TECHNICAL BULLETIN

May 29, 2017
No. 47

SUBJECT: Potential Loosening Of The ACD Yoke System

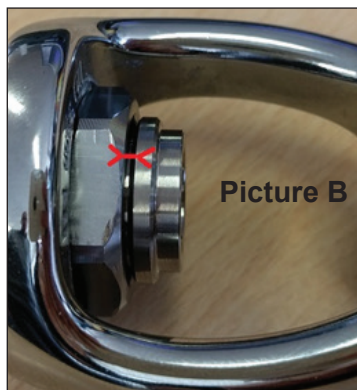
In ACD yoke systems where the Shutter Valve (1) has not been properly tightened to the recommended torque, there is a possibility that the Shutter Valve may loosen itself from the Yoke Retainer (3). This can happen while trying to remove the first stage from the cylinder while the first stage is still under pressure or while partially pressurized (always make sure the regulator is completely de-pressurized before trying to remove the first stage from a cylinder).

INSPECTION: If the Shutter Valve is loose you may see a gap between the Shutter Crown (2) and the Yoke Retainer (3). Picture (A) shows the correct position and picture (B) shows a loosened Shutter Valve (1) with a gap. If there is a gap, you will need to follow the corrective action.

CORRECTIVE ACTION: If you find a gap in the Shutter Crown then you will need to remove the Yoke Retainer (3) from the regulator body and re-torque the Shutter Valve (1) to 27 in-lbs (3 Nm) following the instructions in the maintenance manual.
